Brazos River Authority

Addendum No. 1 Lake Limestone Park #5 Pavement Improvements RFP No. 21-05-1212

**LAKE LIMESTONE
LEON COUNTY, TEXAS**
**PARK NO. 5 ASPHALT PAVEMENT OVERLAY
PLAN**

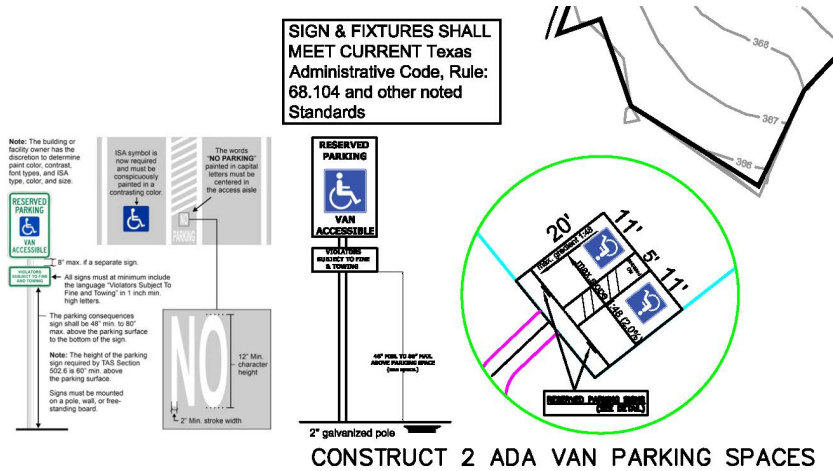
Do you have an enlargement of the handicap detail ?

Attached is an enlarged area of the handicap detail.
